寄件者: Preston TSOI <[REDACTED]>
寄件日期: 2025年10月14日星期二 12:13
收件者: tpbpd/PLAND
副本: Sheldon Ming Sum NG/PLAND; [REDACTED]
主旨: Planning Application No. A/I-TCV/28 - Proposed Temporary Place of Recreation, Sports or Culture (Hobby Farm) for a Period of 3 Years at Lots 1890 RP and 1886 in D.D.1 TC, Tung Chung, Lantau Island - Departmental Comments
附件: 申請文件_P8_20250922.pdf; 申請文件_P5_20250922.pdf; Plan_P3_20250922.pdf; Plan_P2_20250922.pdf; Plan_P2_消防_20250923.pdf; 申請文件_P11_20250922.pdf; 補充資料_申請地點不在道路施工範圍.pdf; 補充資料_由東涌道往申請地.pdf; 補充資料_魚菜共生設施圖_20250728.pdf; 補充資料_魚菜共生運作及洗手間.pdf; 補充資料_渠務工程圖則_202501010.pdf; 補充資料_種植箱_2.JPEG; 補充資料_種植箱_1.JPEG; 補充資料_種植箱_3.JPEG
類別: Internet Email

感謝貴署及各部門的意見，申請人現更新及補充資料，將附件頁取代舊頁，謝謝！如有查詢請電聯 [REDACTED] 陳生或 [REDACTED] 蔡生。

Drawing No. P02	Ver. 07
Project PROPOSED TEMPORARY PLACE OF RECREATION, SPORTS OR CULTURE (HOBBY FARM) FOR A PERIOD OF 3 YEARS	
LOT NOS. 1886 AND 1890RP IN D.D. 1, TUNG CHUNG, TUNG CHUNG ROAD, LANTAU ISLAND, NEW TERRITORIES	
Drawing Title LAYOUT PLAN	
Scale of A4	
Drawn	Date 22-09-2025
Revised	Date

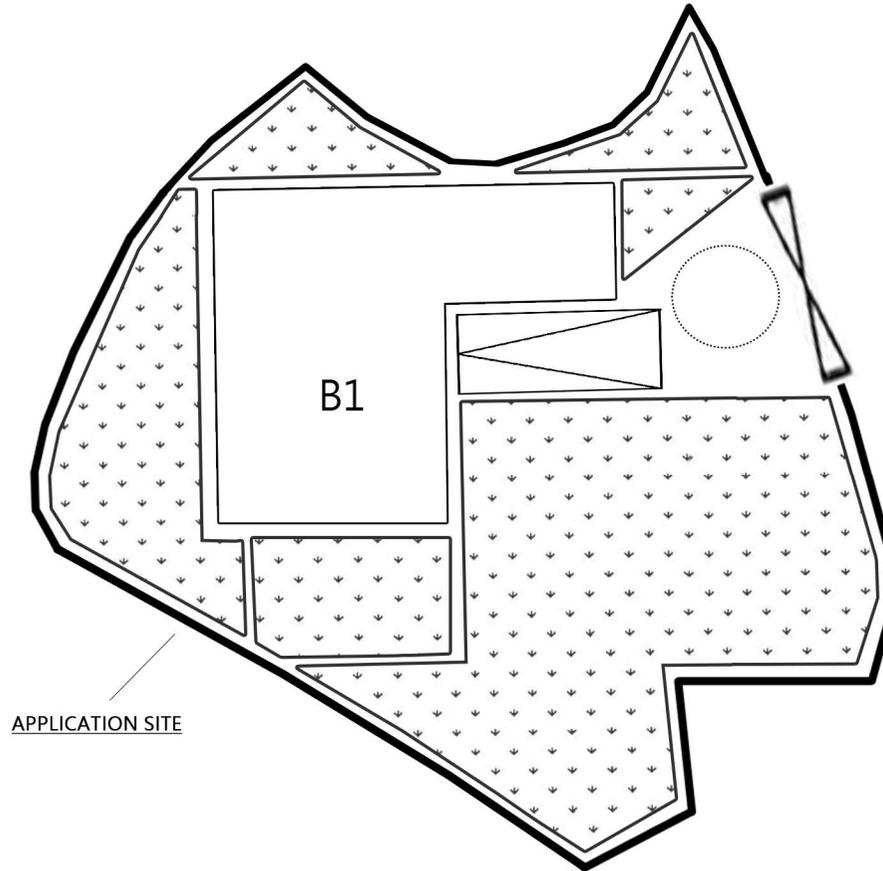
Urgent Return receipt Expand Group Restricted Prevent Copy Confidential
Comments from Chef Town Planner/Urban Design & Landscape
(Contact Person: Ms. Isabella TSUI, Tel: [REDACTED])

回應：申請人擬議將露天農用面積增至約 60%(約 167.3 平方米)。

Floor Plan(B1)

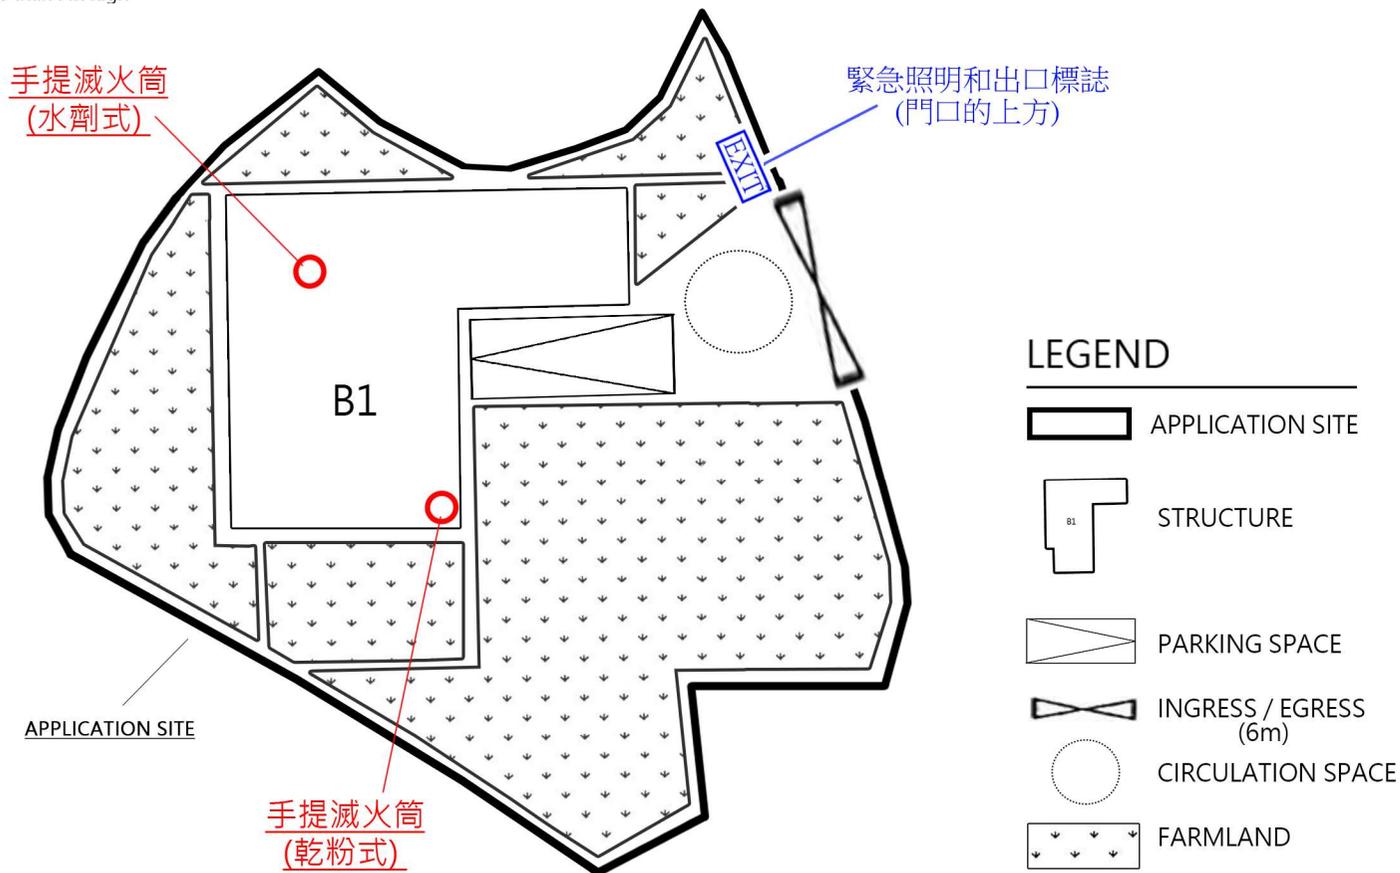
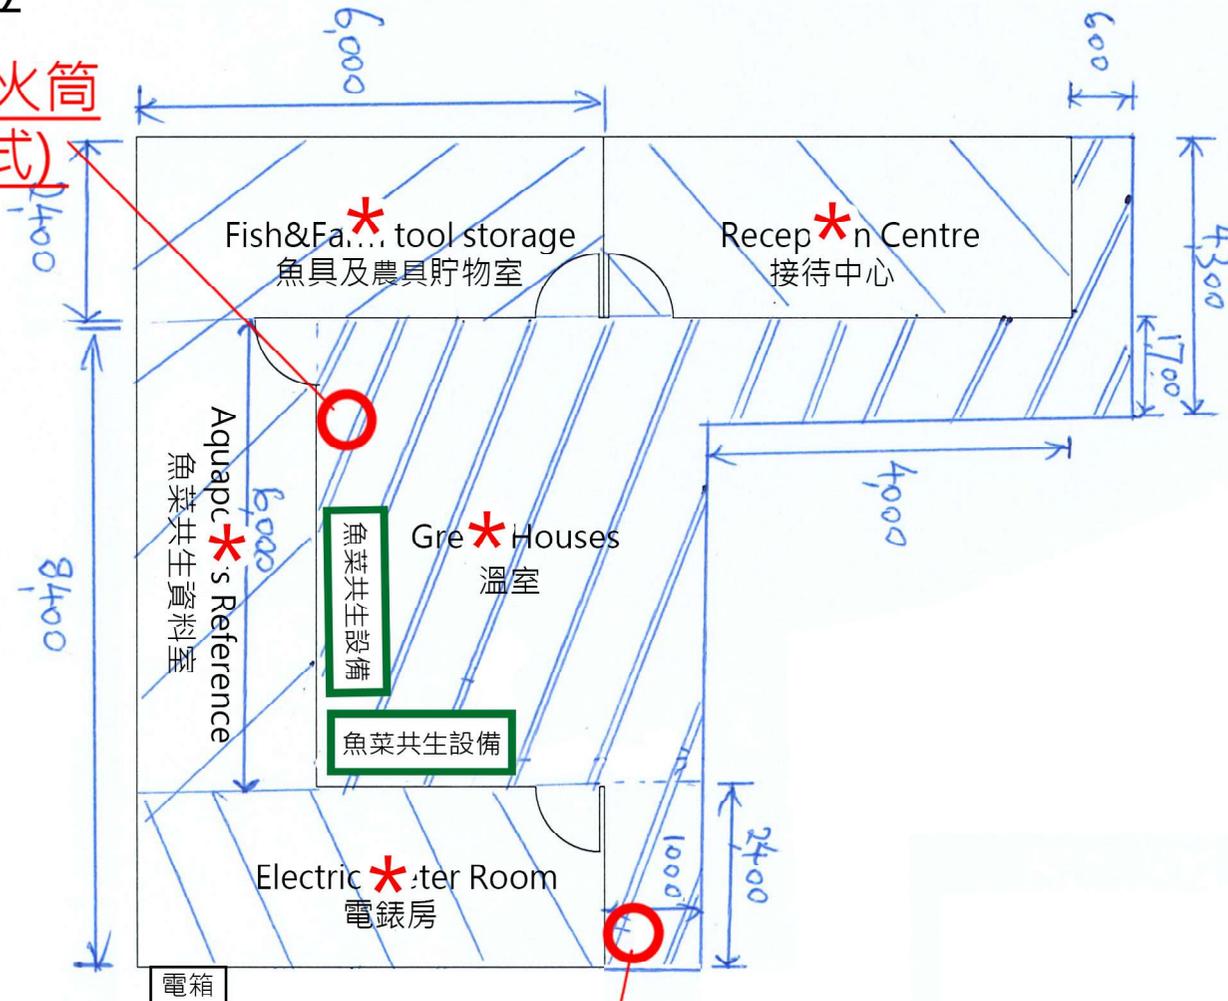
Comments from Director of Fire Services
(Contact Person: Mr. CHUNG Chun-ho, Tel: [REDACTED])

回應：申請人擬議將設置 1 個手提式滅火筒(水劑式)、1 個手提式滅火筒(乾粉式)、1 個出口指示牌及 5 個火警傳感器(無線互通)。

根據路道路工程圖則編號 RD/GZ125A，申請地點不在道路施工範圍。

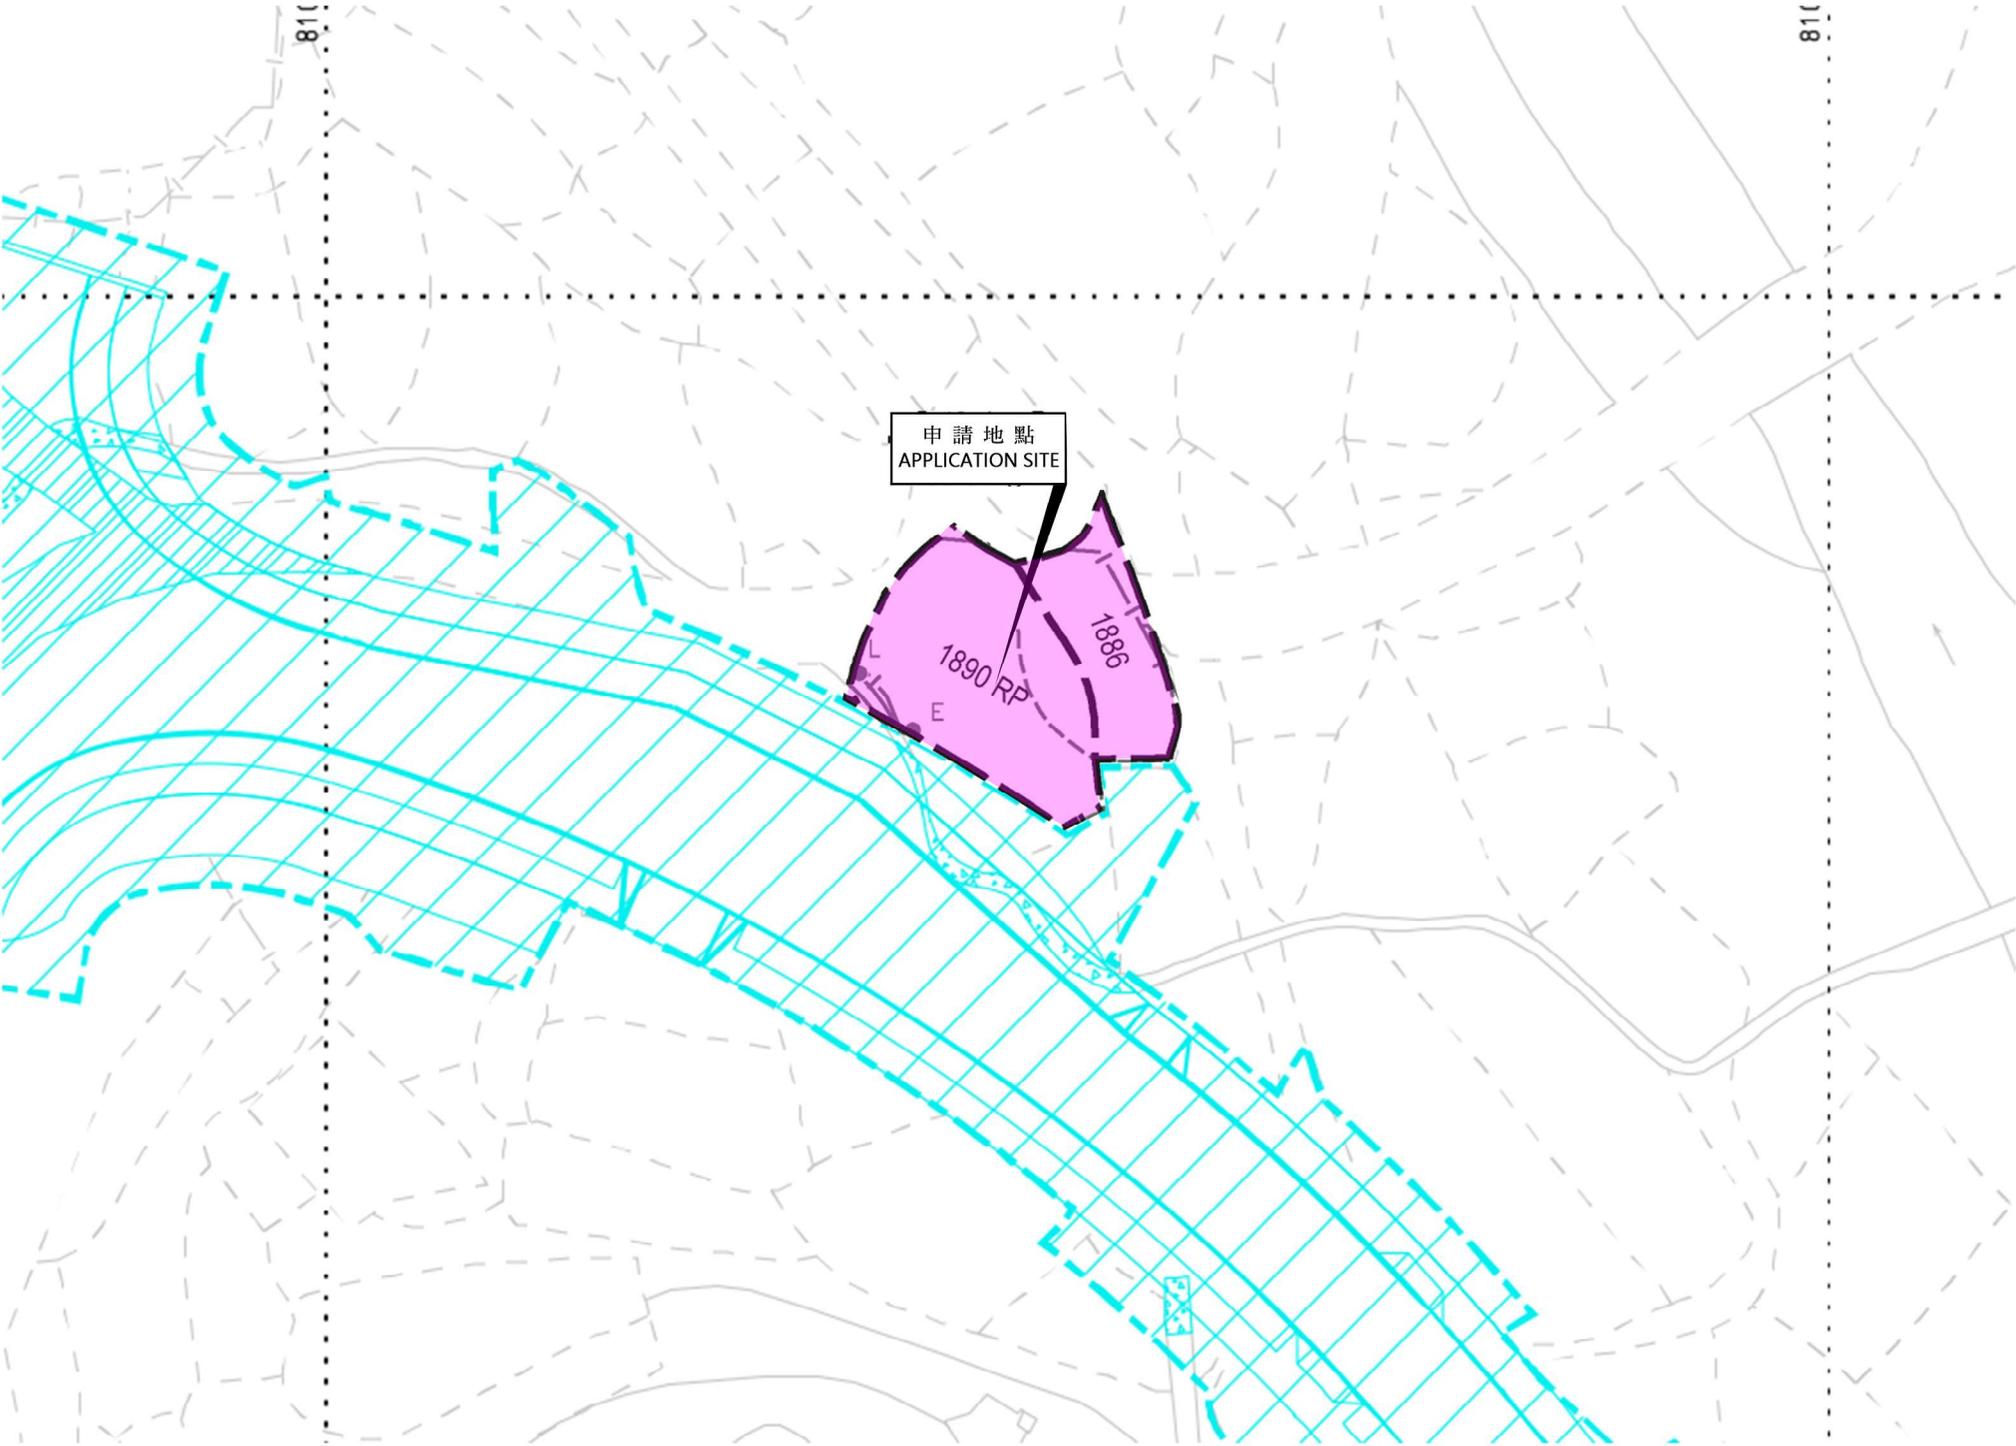
1. The subject application site is in close proximity to the proposed Road L26 and polder under CEDD's Tung Chung New Town Extension project. The 3-years application period may overlap with the construction period of the said works. The applicant shall liaise with CEDD and the future contractor for interfacing issues, if any.

回應：根據路道路工程圖則編號 RD/GZ125A，申請地點不在道路施工範圍，因此本申請不影響道路施工。
